**Item 4.****Development Application - 420 and 422-424 Kent Street and 275 and 277  
Clarence Street, Sydney**

File No.: D/2018/1577

**Summary**

**Figure 16:** Kent Street elevation and the extent of cantilever as recommended by Council to delete the outer cantilever.

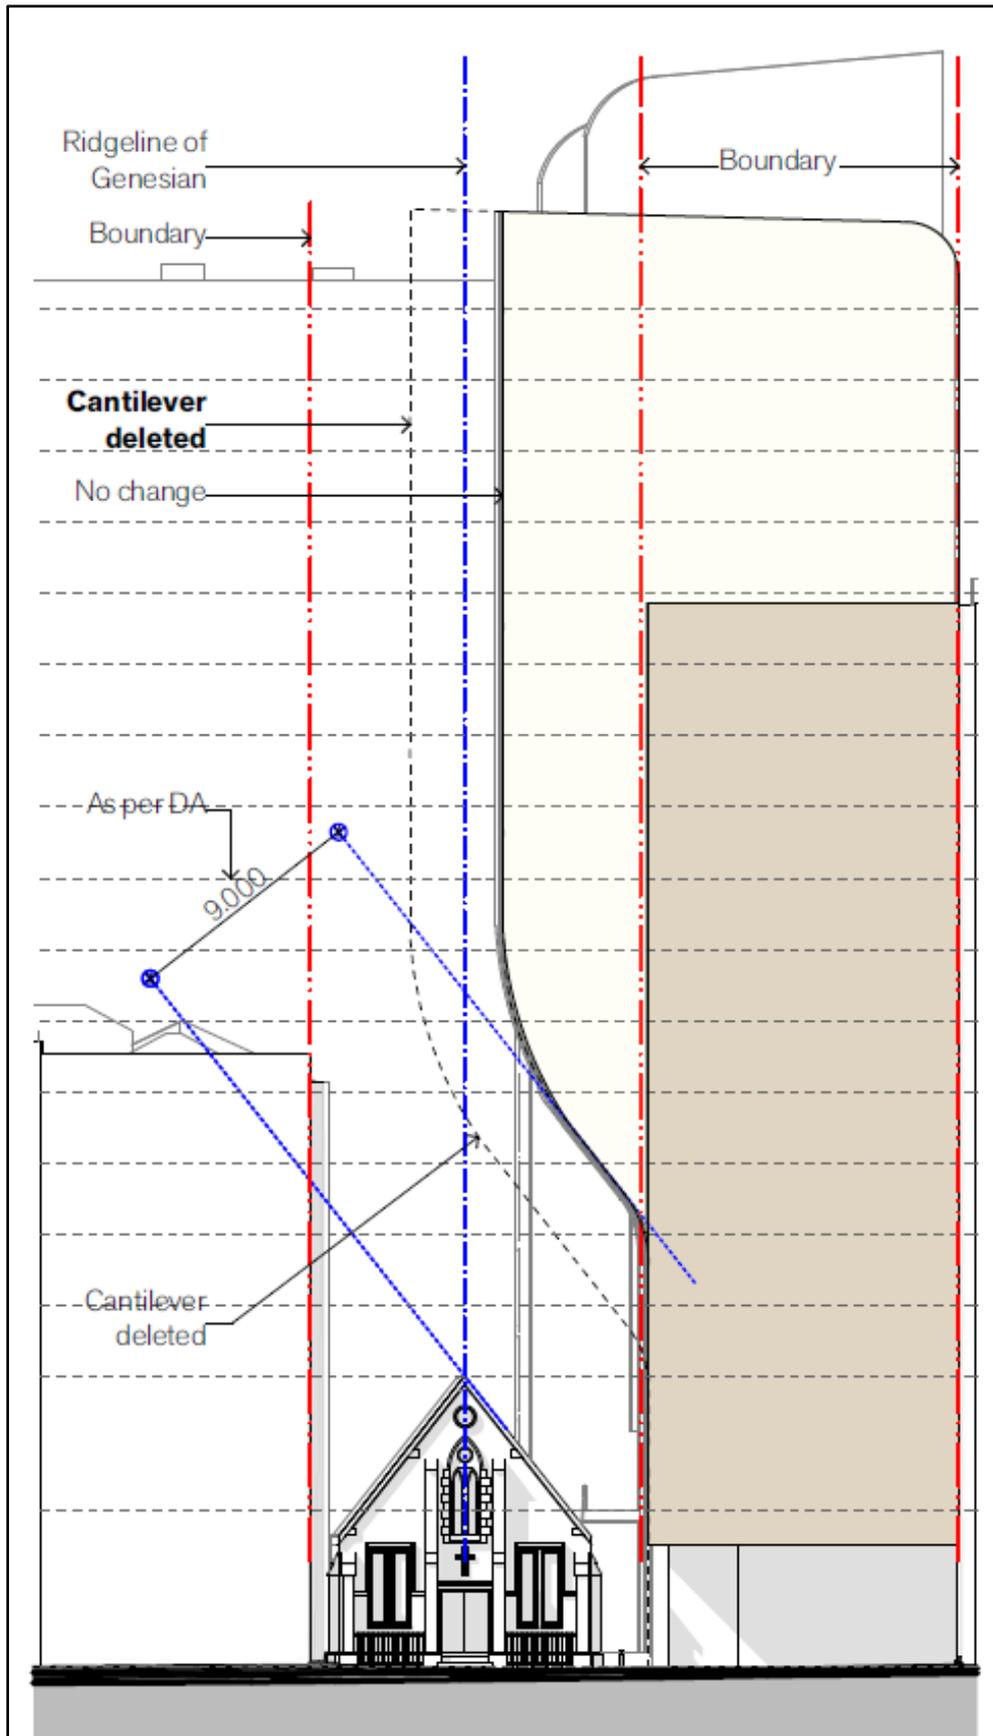
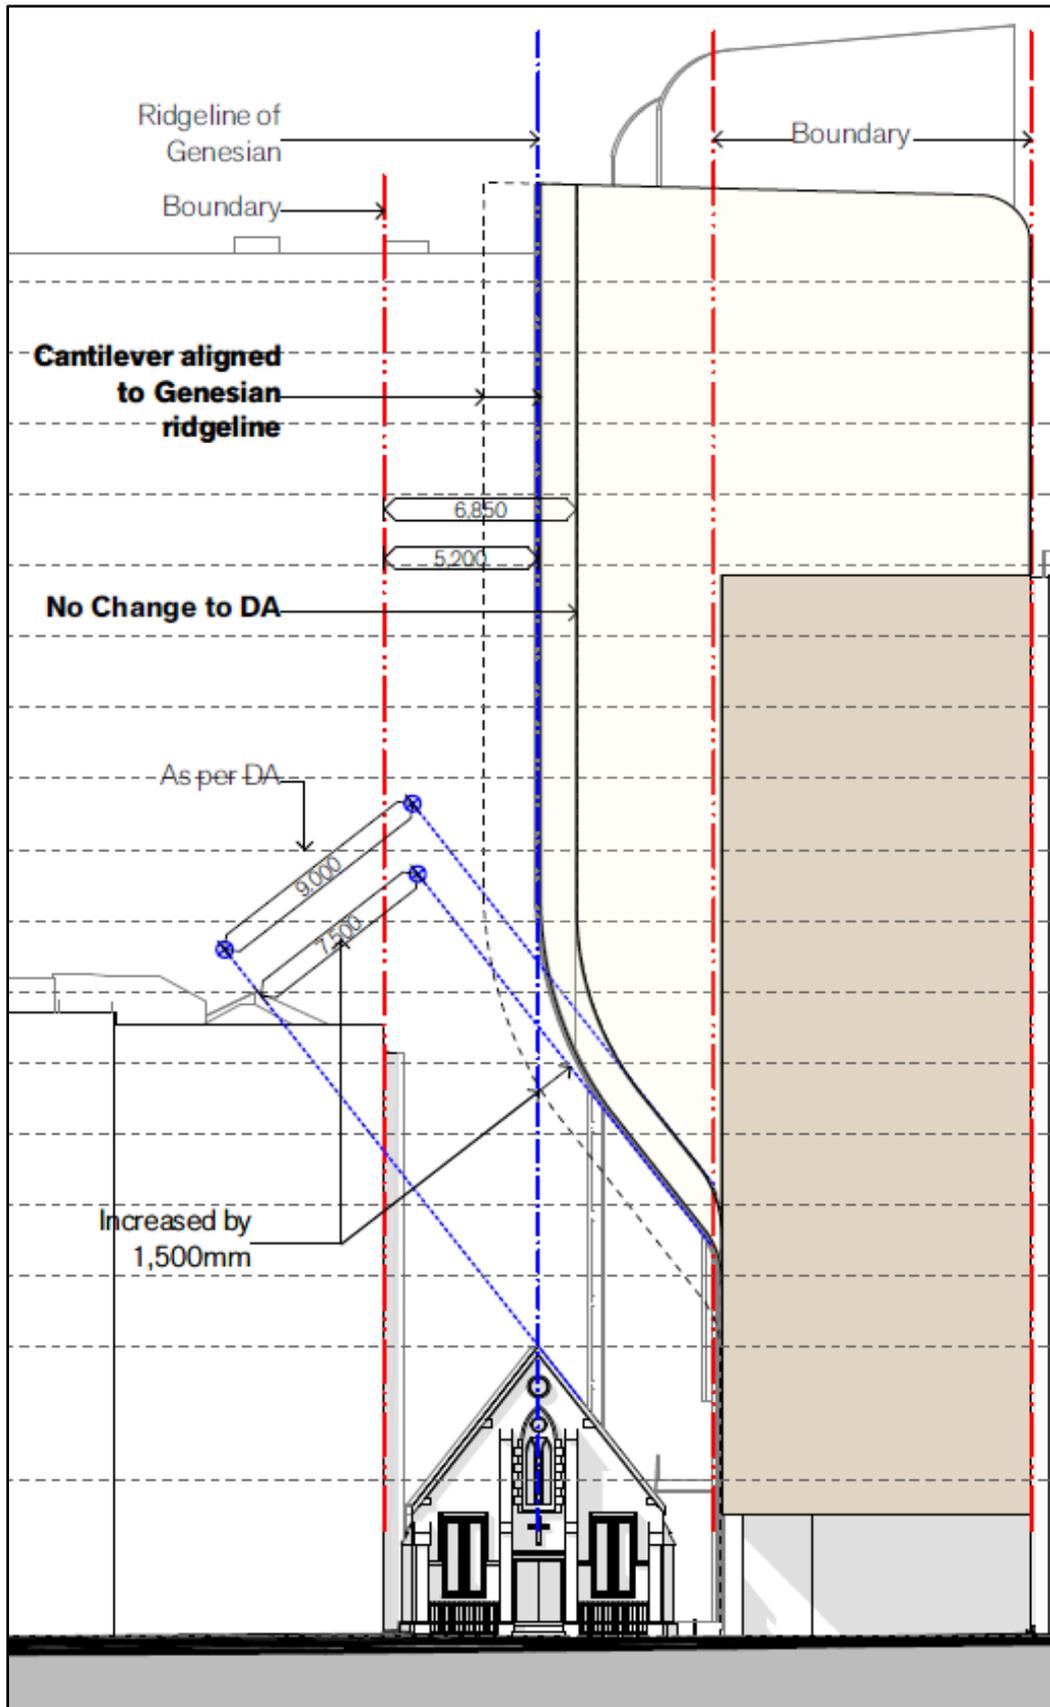
49. Additionally, the proposal was referred to the Design Advisory Panel (DAP). DAP and Council's Heritage Specialist shared the same view in that the extent of the cantilever over the church was excessive and overwhelmed the curtilage of the heritage building. As such, amended plans were requested to be provided, which sought to delete the outer cantilever of the new development.

- (c) The degree of cantilever over the adjacent heritage building was excessive and consideration should be made to delete the outer cantilever. This would result in the reduction and replanning of the hotel rooms;

51. On 31 July 2019, revised architectural floor plans were submitted to Council, demonstrating that the reduction to the extent of the cantilever did not unreasonably impact on the replanning of the affected hotel rooms. The modification reduced the GFA of the development and did not alter the proposed number of hotel rooms.

52. Overall, the amended design of the development is considered to be satisfactory. The proposal has an acceptable heritage impact and would foster a continual use of the building for cultural uses. The cantilever allows sufficient visual separation with the existing church building and at the same time affords hotel rooms in the centre of the new building to have access to natural light and views of Kent Street.
53. Extracts of the Cantilever Setback Study are illustrated in Figures 15 and 17 below.

**Figure 17:** Kent Street elevation and extent of the cantilever as proposed, increasing the separation of the underside of the cantilever and realignment of the outer edge with the apex of the Genesian Theatre roof.
